# AGENDA

## Town Planning Committee

Tuesday, 1 June 2021 at 6.30pm

ELEVATION 2

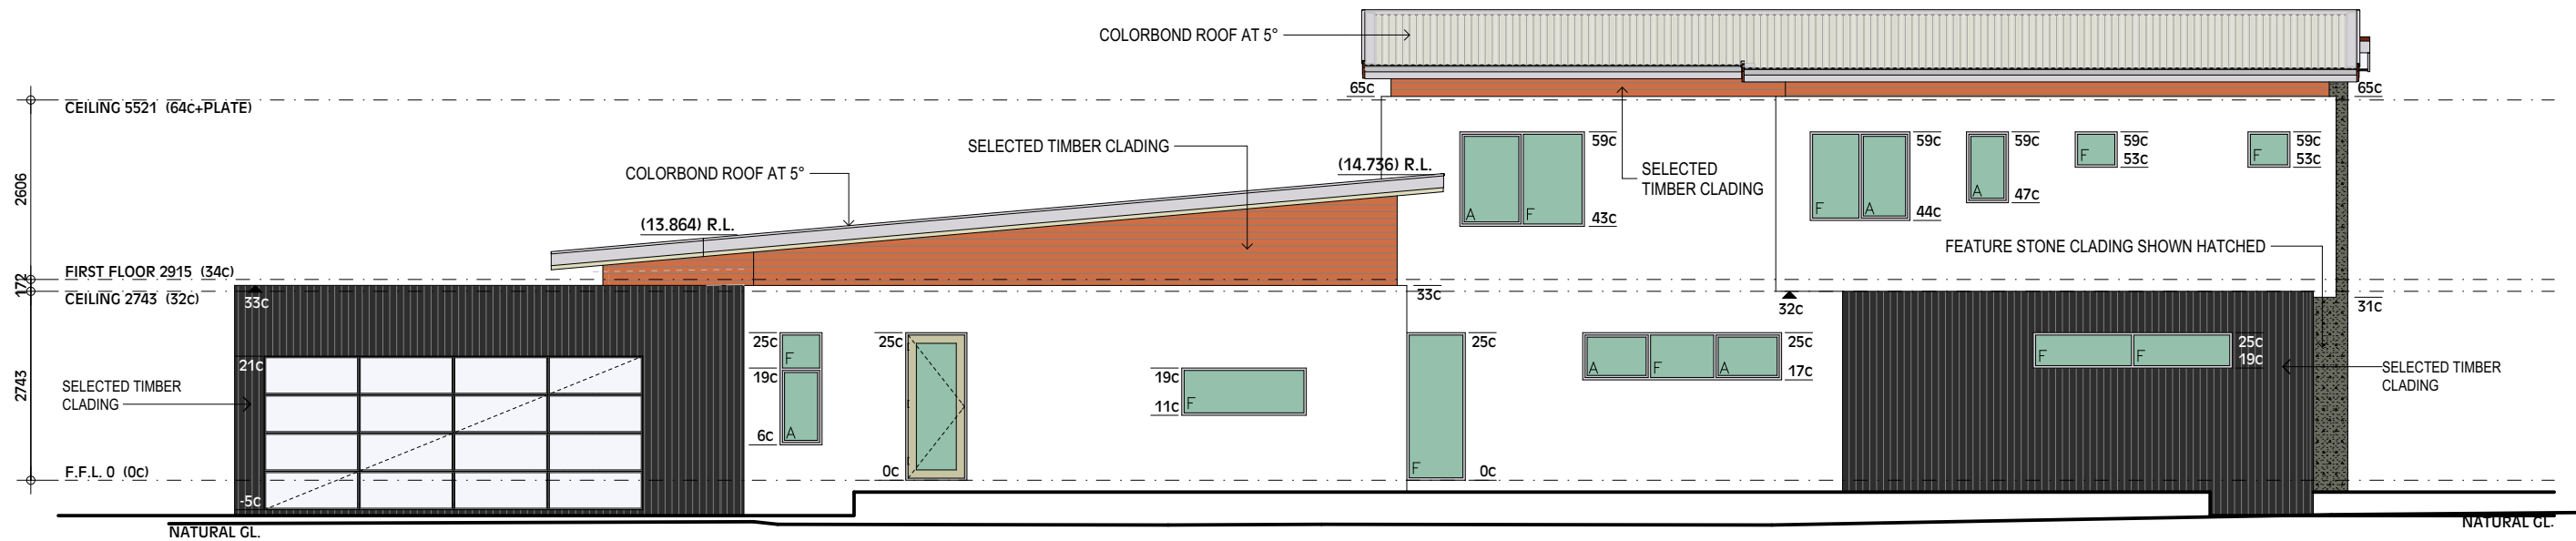
- The Committee believed (Elevation 2 – streetline sight line) that the visual streetscape sightline is not an accurate representation of the parts of the dwelling that will be seen from the street and a revised elevation is required.
